Technical Service Bulletin

94 "Electrical system fault" is displayed in the instrument cluster, DTC: P18F100, P0A1B00, U140500
94 23 61 2068617/2 January 17, 2023. Supersedes Technical Service Bulletin Group 94 number 22-60 dated November 18, 2022, for reasons listed below.

Model(s)	Year	VIN Range	Vehicle-Specific Equipment
Q4 e-tron, and Q4 Sportback e-tron	2022	All	Not Applicable

Figure 1: 10 Pin connector.

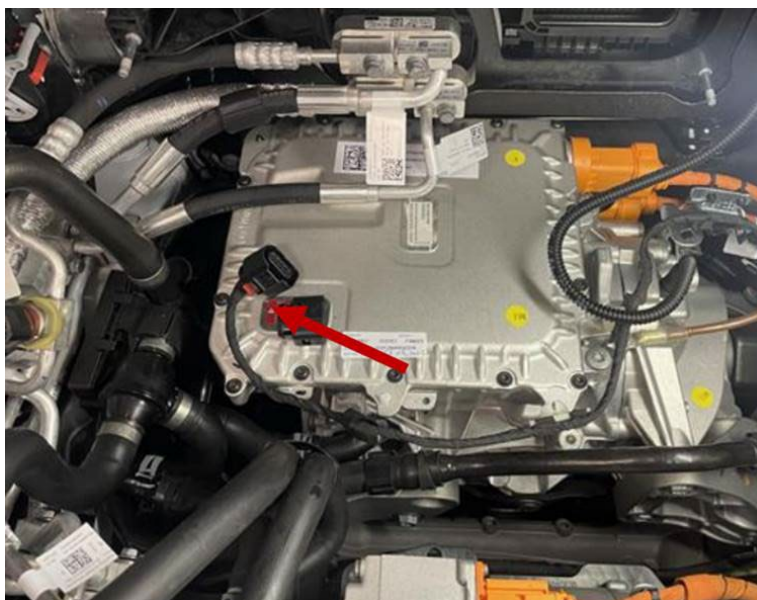
Inspect connector T10 at power electronics 2 for electric drive JX4 for spread or damaged contacts:

If any damage is found to the pins or connector, replace the 10-pin connector and associated wires/pins.

Note: **DO NOT** de-pin the connector. Cut the connector off the harness leaving approximately 5cm of the harness attached to the connector. Retain the connector and harness section for analysis.

Replace the connector and repair the harness using **VAS 1978B**.

In the warranty claim ensure part number **4H0 973 715 A** is claimed as the causal part.
